**Re: STB Finance Docket No. 34284, Southwest Gulf Railroad Company –
Construction and Operation Exemption – Medina County, TX**

This will respond to your July 8, 2005 letter posing a series of questions to applicant Southwest Gulf Railroad ("SGR") in connection with the environmental review of SGR's proposed rail line.

Figure 1. INDUSTRY TRACK

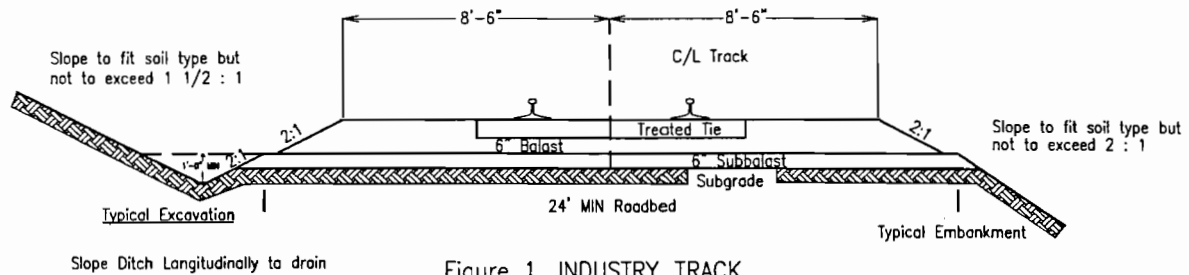
3. **Please provide the typical roadbed cross-section template SGR used in modeling the proposed roadbeds showing roadbed widths, side slopes, ditches, and berms. If more than one typical template was used, please provide all templates and the corresponding station limits along which the templates were applied to determine the cut and fill quantities. Please specify the type of material(s) that were used for the rail bed (soil, rock, etc).**

In its preliminary engineering analysis of the Proposed Route and the alternatives, and in the absence of subgrade material data that will not be available until the final engineering stage, SGR

applied widely accepted engineering practices in assuming a suitable, consolidated formation, with sufficient bearing capacity for the intended tracks. SGR has utilized a typical cross-section of an industry track as a template for modeling the proposed roadbed. The cross section appears in Exhibit 2.

SGR intends to utilize crushed limestone base for the rail bed and a combination of trap rock and limestone aggregate for the ballast material.
